From: Sparkes, Bill TRAN:EX
Sent: Thu, December 7, 2006 2:51 PM
To: Peterson, Joe J TRAN:EX
Subject: RE: King file - Kaleden 17486

To: Bill Sparkes, Joe Peterson
Copy: Randy Kowalchuk, Jim Morrison
Date: December 18, 2006
From: Brad Elenko
Subject: Naramata Benchlands PLA – Follow-up

Re: Proposed Subdivision – Sublot 14, D.L. 2711, SDYD, Plan 1190 except
Plans A62, 29843, 38736, KAP44343, KAP45544, KAP46231,
KAP54137, & KAP57167
Your File – 02-008-17281

SCALE:	1:1500	
DRAWN BY:	TCD	FIELD BOOK
SIGN BY:		
DATE:	19/03/07	
DRAWING No.:	1941-24	
SHEET No.:	24/28

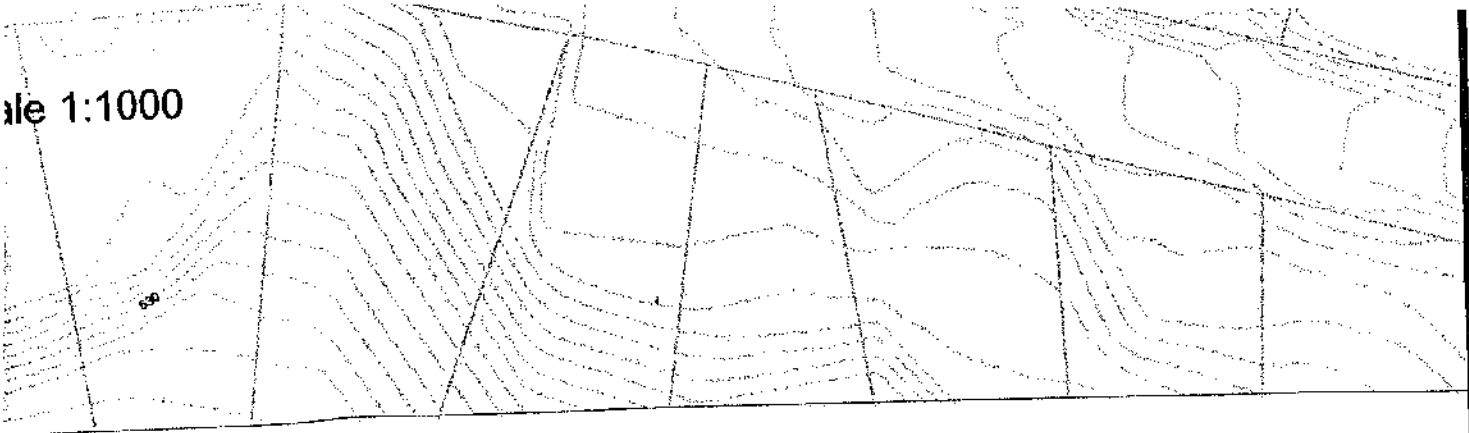
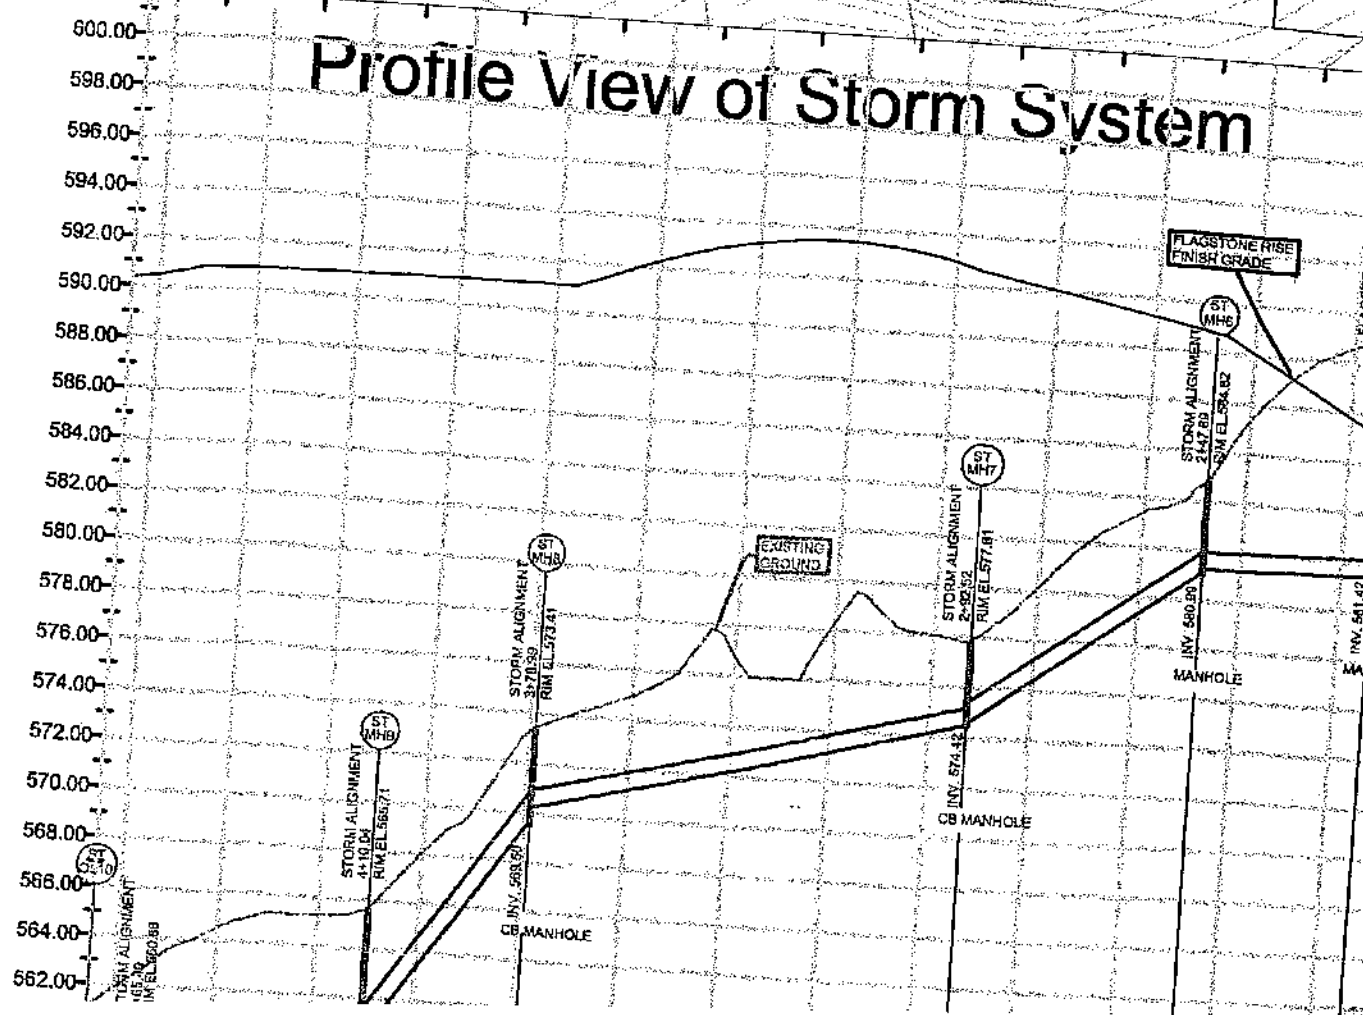
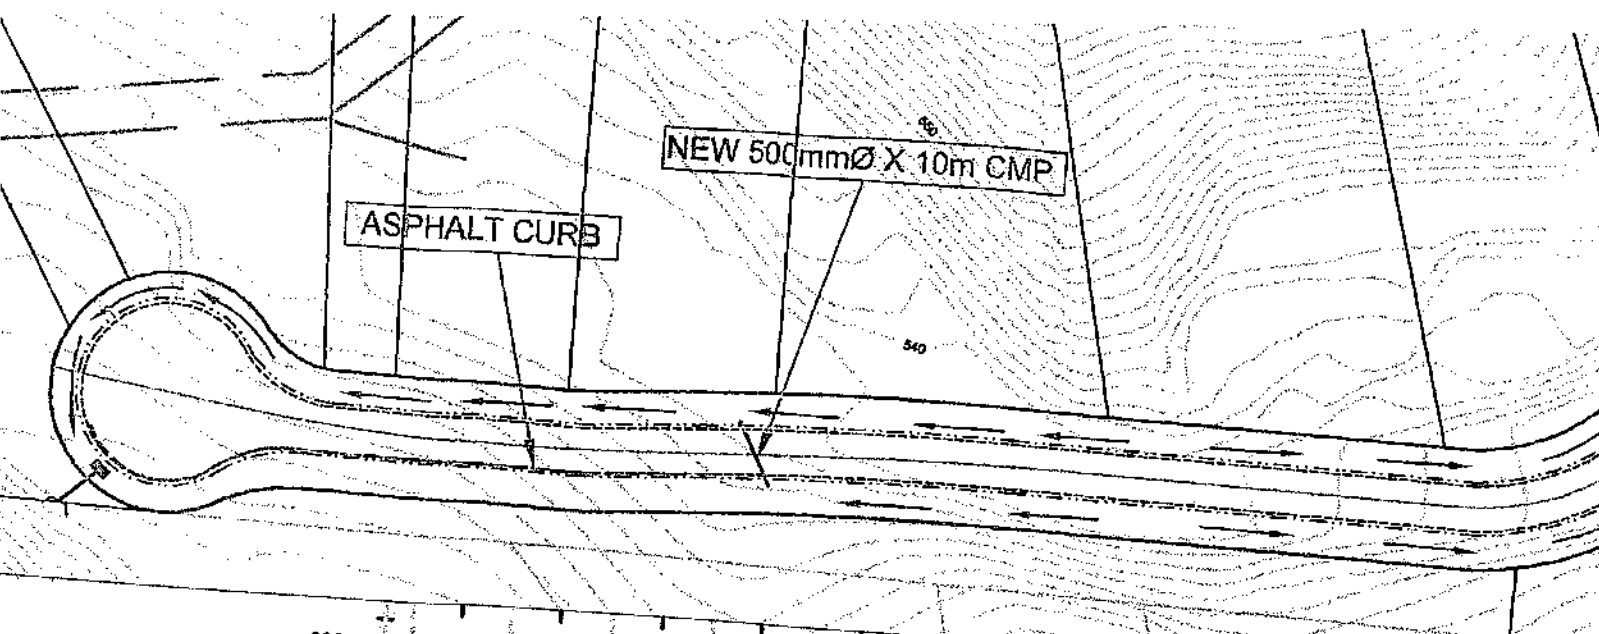
The Storm water Drainage plan drawing 1941 - 24 Wildstone Engineering Plan clearly identifies the storm water coming down Slate Place on both sides of Slate Place and then draining into Arawana Creek.
